Item ID: D407-667-205

Item Name: Crosstube Aft

DRAWING NO. D407-667-245	TITLE CROSSTUBE ASSY (407 HIGH AFT)	REV. F	DART AEROSPACE LTD ENGINEERING ORDER		D.E.O. NO. D407-667-245-F-1	SHEET NO. SHEET 1 OF 2	SCALE NTS
DRAWN <i>B</i>	CHECKED <i>Q</i>	MFG. APPR. <i>E</i>	APPROVED <i>MP</i>	DE APPR. <i>H</i>			
DATE 11.04.08	DATE 11.04.12	DATE 11.04.12	DATE 11.04.12	DATE 11.04.12

DRAWING NO. D407-667-245	TITLE CROSSTUBE ASS'Y (407 HIGH AFT)	REV. F	DART AEROSPACE LTD ENGINEERING ORDER		D.E.O. NO. D407-667-245-F-2	SHEET NO. SHEET 1 OF 1	SCALE NTS
DRAWN 97	CHECKED ASS	MFG. APPR. E	APPROVED MP		DE APPR. th		
DATE 11.09.07	DATE 11.09.19	DATE 11.09.19	DATE 11.09.19		DATE 11.09.19

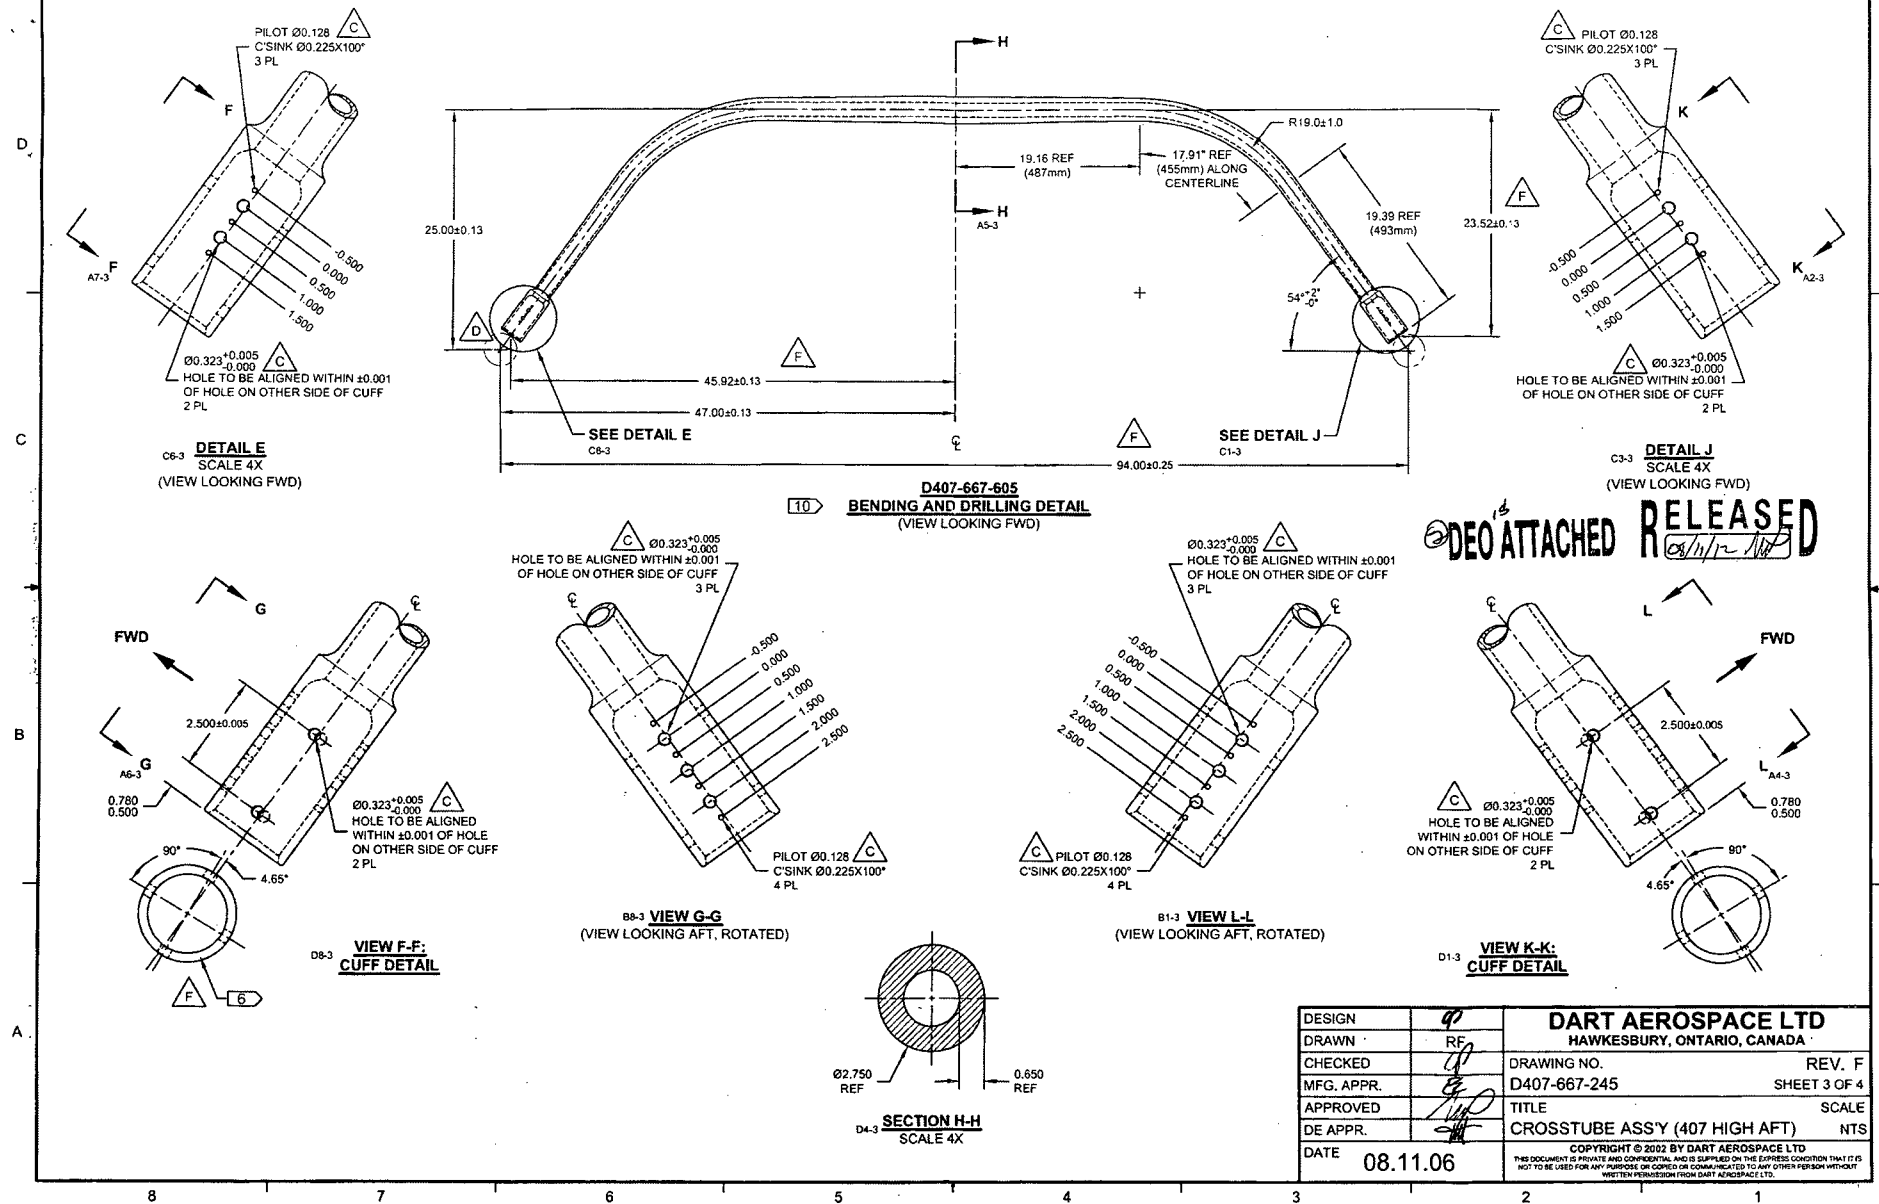
F	REFORMAT NOTES TO NEW STANDARDS (ZN B8-1); RELOCATED FLAG # 6 (ZN A8-3) PER NCR 210; REMOVED REF. & ADD TOLERANCES (ZN C6-3, C4-3 & D2-3)	RF	08.11.06
E	8.02 AND 8.53 WERE 8.40 AND 8.90 (ZN D5-2); REORGANIZED VIEWS AND REFORMATED DRAWING TO CURRENT STANDARDS. REASONS: CLAMPS MOVED 0.375 TOWARD CL TO ELIMINATE INTERFERENCE WITH AIRCRAFT MOUNTS. REFERENCE: FAR#08-21 AND ECN#1225	MB	08.07.24
D	ADD VIEW FOR OEM SKID HOLES, ROTATE ORIENTATION OF CLAMPS SECTION F-F, REMOVE -851 ABRASION STRIP, ADD MAGNOBOND 6398, ADD CUSHION	PH	07.02.07
C	ADD HOLES AND NUT PLATES FOR COMPATIBILITY WITH BHT/AA SKIDTUBES	PH	05.07.26
B	ADD CHAFING SHIELD	CP	03.05.21
A	NEW ISSUE	CP	02.05.13
REV.	DESCRIPTION	BY	DATE
DESIGN	97	DART AEROSPACE LTD HAWKESBURY, ONTARIO, CANADA	
DRAWN	RF		
CHECKED	97	DRAWING NO.	REV. F
MFG. APPR.	97	D407-667-245	SHEET 1 OF 4
APPROVED	97	TITLE	SCALE
DE APPR.	97	CROSSTUBE ASS'Y (407 HIGH AFT)	NTS
DATE	08.11.06	<small>COPYRIGHT © 2002 BY DART AEROSPACE LTD THIS DOCUMENT IS PRIVATE AND CONFIDENTIAL AND IS SUPPLIED ON THE EXPRESS CONDITION THAT IT IS NOT TO BE USED FOR ANY PURPOSE OR COPIED OR COMMUNICATED TO ANY OTHER PERSON WITHOUT WRITTEN PERMISSION FROM DART AEROSPACE LTD.</small>

DRAWING NO. D407-667-245	TITLE CROSSTUBE ASSY (407 HIGH AFT)	REV. F	DART AEROSPACE LTD ENGINEERING ORDER	D.E.O. NO. D407-667-245-F-1	SHEET NO. SHEET 2 OF 2	SCALE NTS
DRAWN	CHECKED	MFG. APPR.	APPROVED	DE APPR.		
DATE 11.04.08	DATE 11.04.11	DATE 11.04.12	DATE 11/04/12	DATE 11.04.12

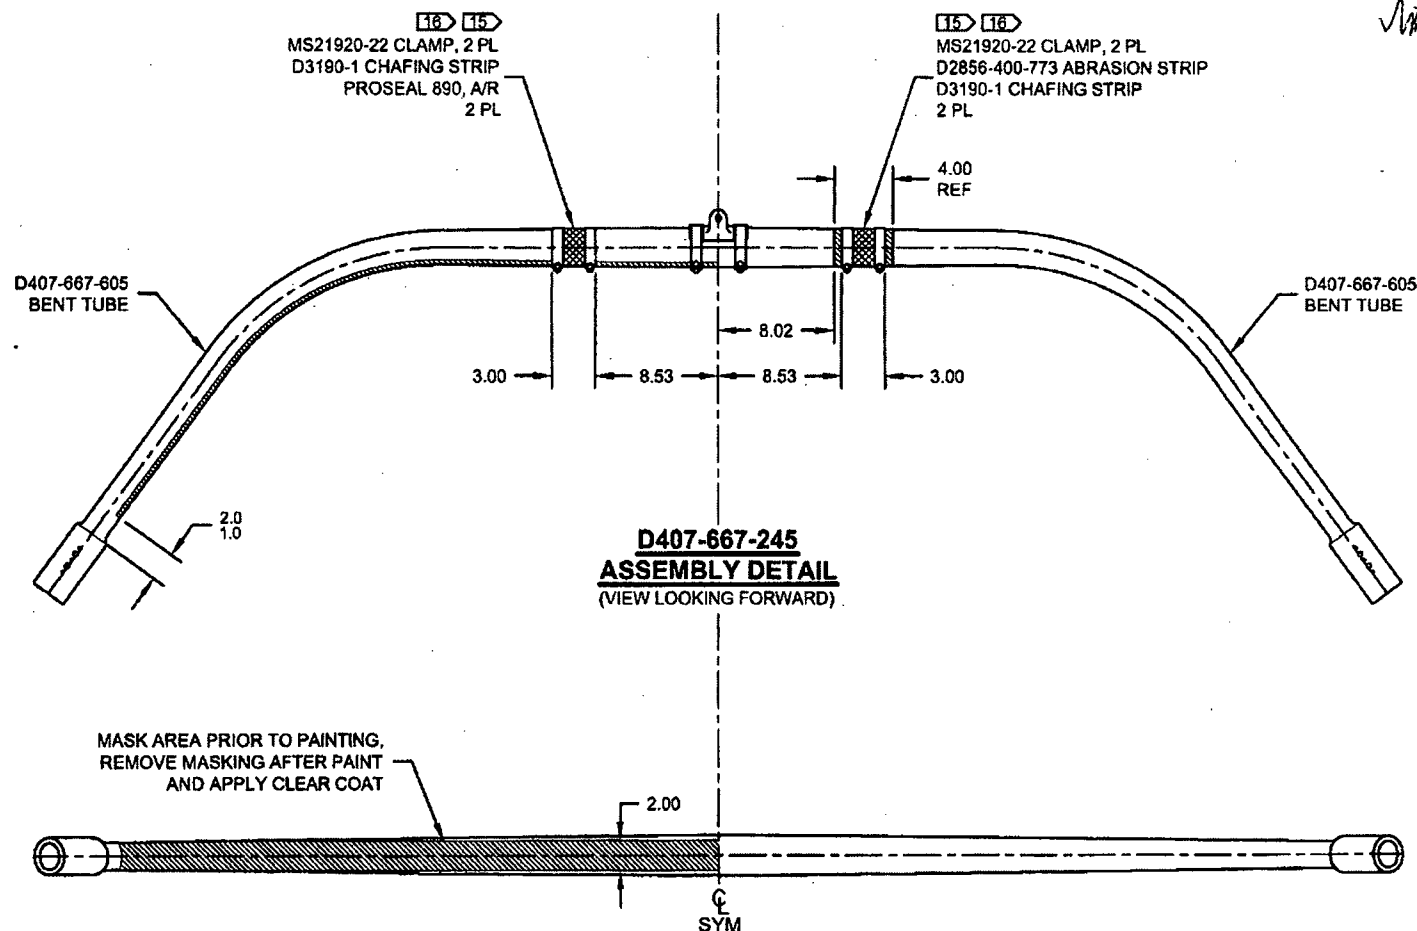
NOTES 2 AND 15, SHEET 1 ARE AMENDED AS FOLLOWS:

- 2) FINISH: CHEMICAL CONVERSION COAT PER DART QSI 005 4.1
PRIME INSIDE AND OUTSIDE PER DART QSI 005 4.2
MASK UNDERSIDE OF CROSSTUBE AS SHOWN (HATCHED AREA) AND
PAINT OUTSIDE PER DART QSI 005 4.2
REMOVE MASKING AND APPLY CLEAR COAT
- 15) APPLY A THIN COAT OF PROSEAL 890 ON INSIDE CONCAVE SURFACE OF D3190-1
CHAFING SHIELDS AND LET CURE PER MANUFACTURER'S INSTRUCTIONS. INSTALL
PROSEALED D3190-1 CHAFING SHIELDS ONTO CROSSTUBE BY APPLYING A THIN COAT
OF PROSEAL 890 ONTO CROSSTUBE. BE SURE TO ELIMINATE ANY AIR GAPS.

IS:

WAS:
